**REQUEST FOR INFORMATION (RFI)
36C250-18-B-0081**

PROJECT NUMBER:	610-15-100	Please ensure that before submitting questions or requests for clarification that you thoroughly read the solicitation, specifications, drawings and other pertinent documents. When submitting questions on this project the Government requires contractors to specifically identify the specification and/or solicitation section(s) or drawing number(s) in reference to the question or request for clarification submitted. No question or request for clarification will be answered by the Government unless the above requirements are met. Failure to comply may prevent the Government from responding in a timely manner.
PROJECT TITLE:	Demolish Bldgs. 7,10,11,18,24,60 and Connecting Corridors	
PROJECT LOCATION:	Department of Veterans Affairs VA Northern Indiana HCS 1700 E. 38 th Street Marion, IN 46953

RFI NO.: #E5	DATE:	SPEC/DWG. REFERENCE(s): ED-101 – Coded Note #25
REPLY NEEDED BY: 1-2-2018

^ SITE PLAN

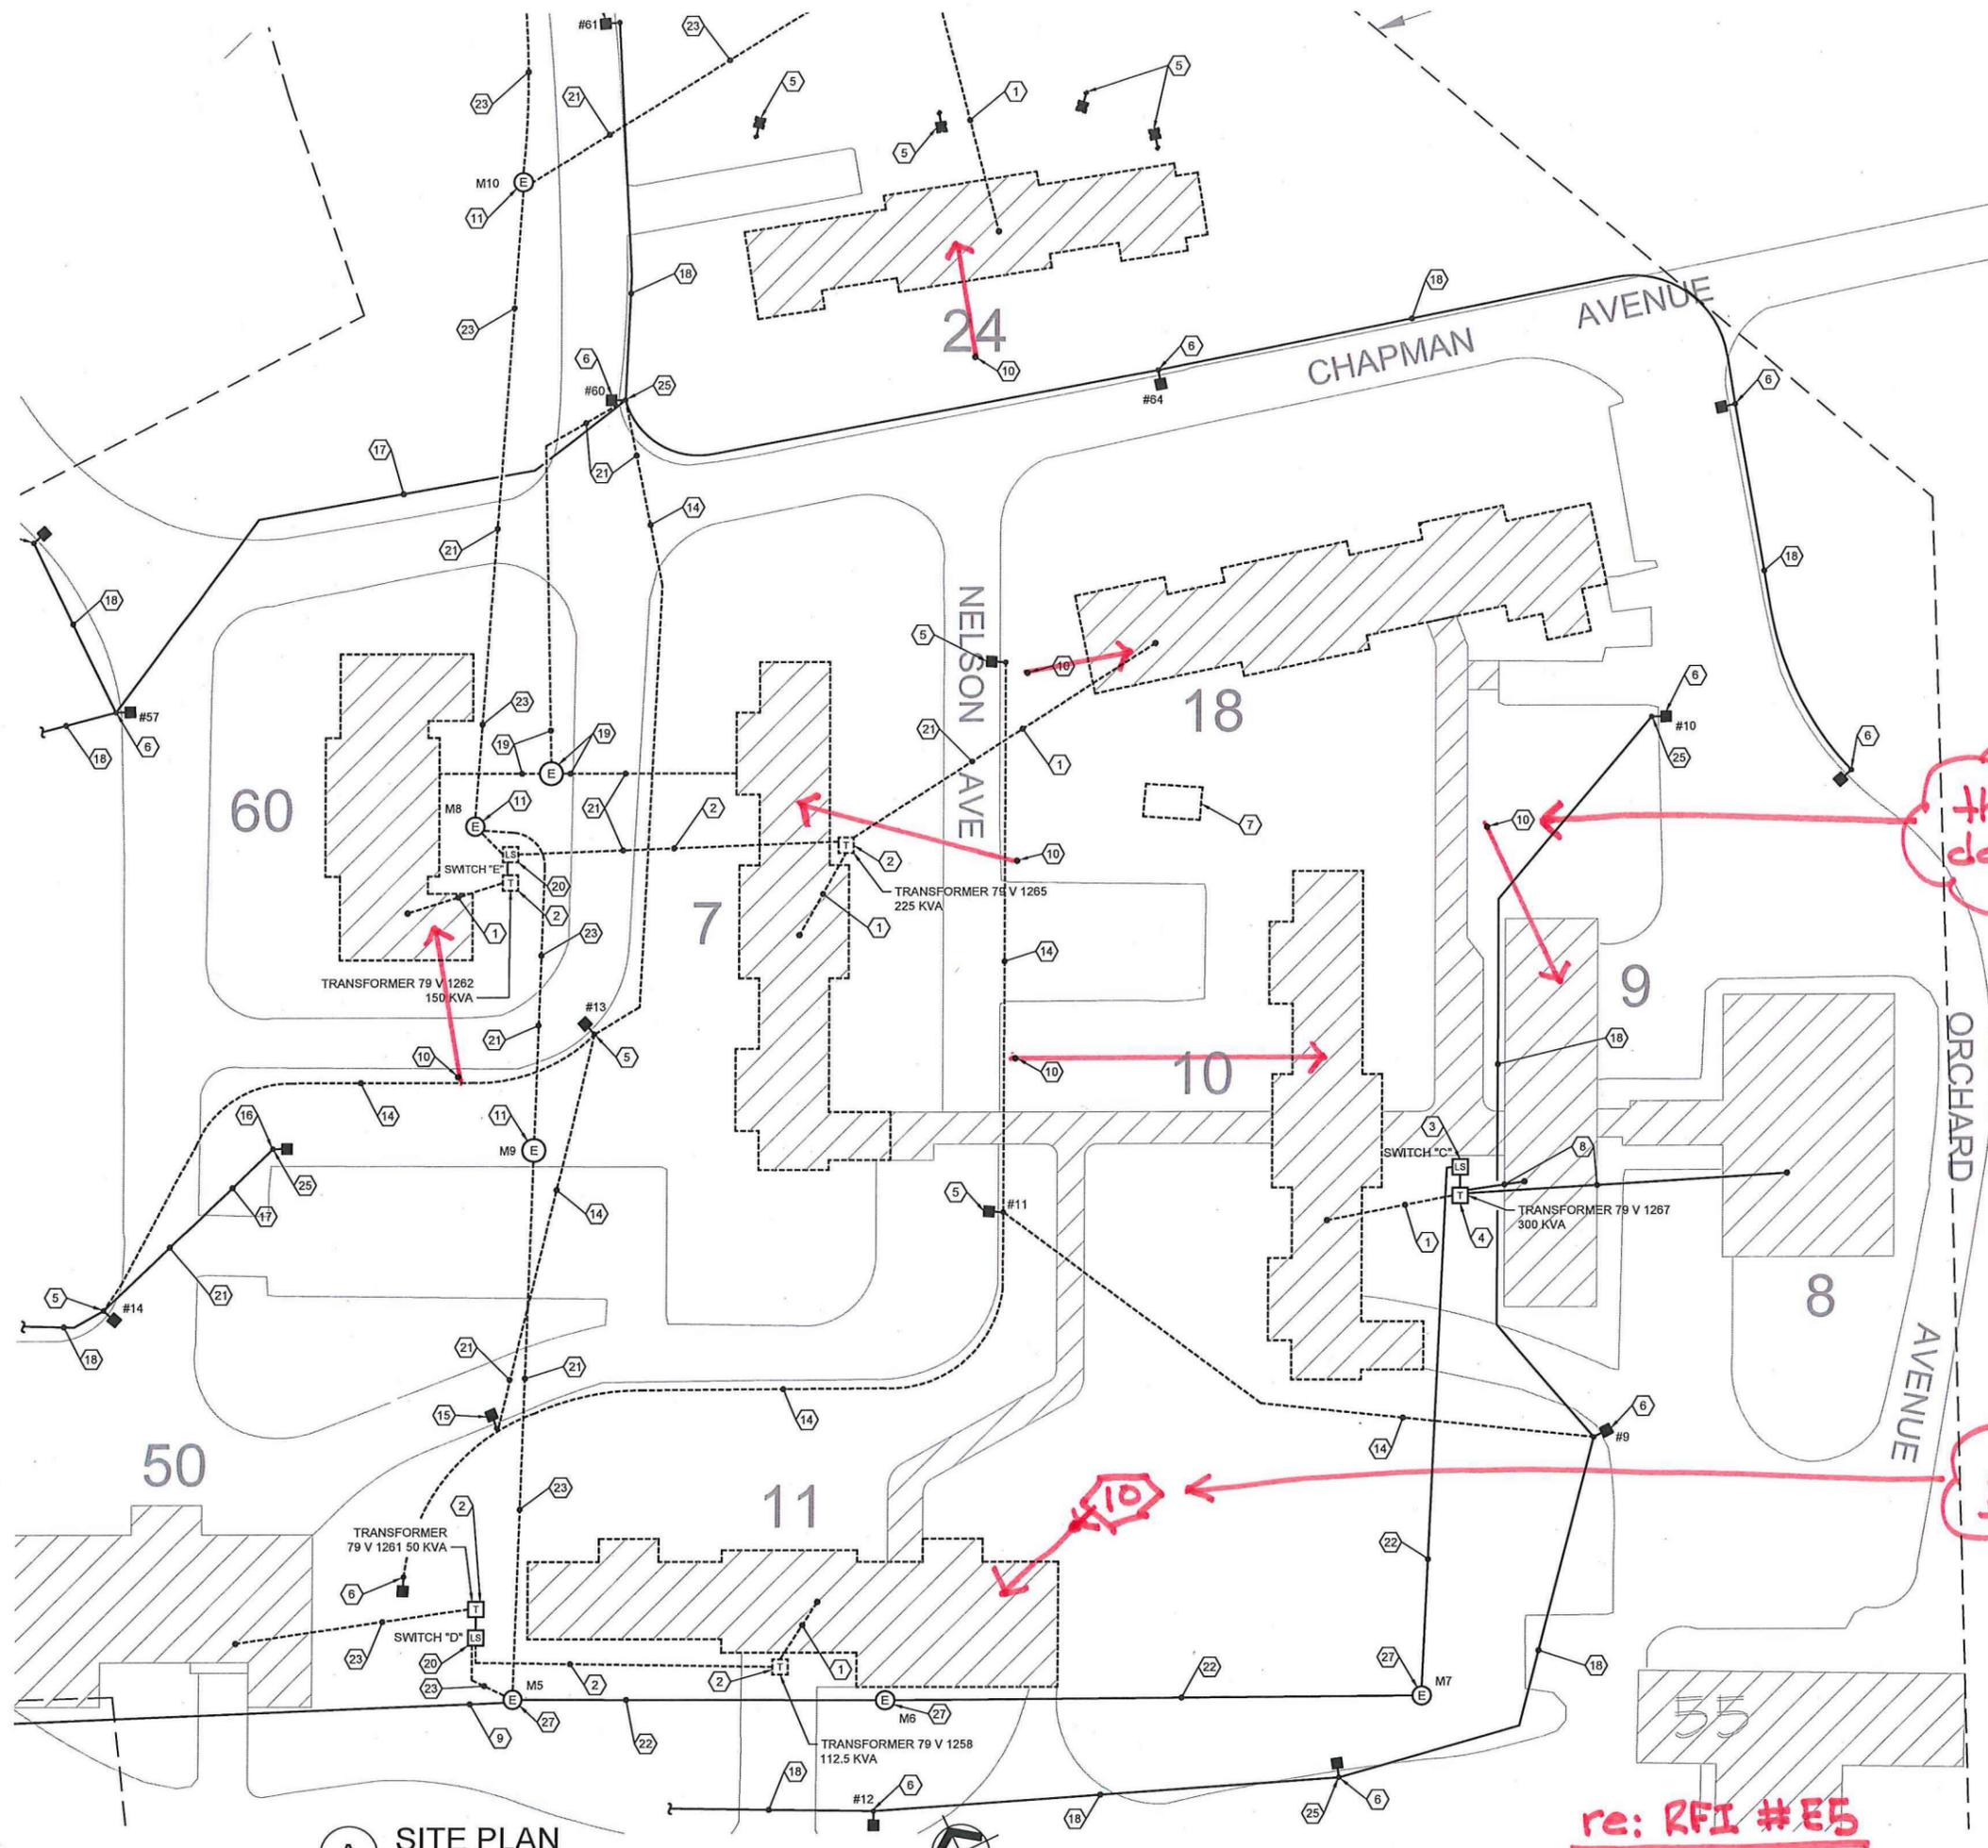
Can VA provide information as to which building the tamper switches are wired to?

this PIV to remain.
do not remove

add removal of
this PIV

re: RFI # E5
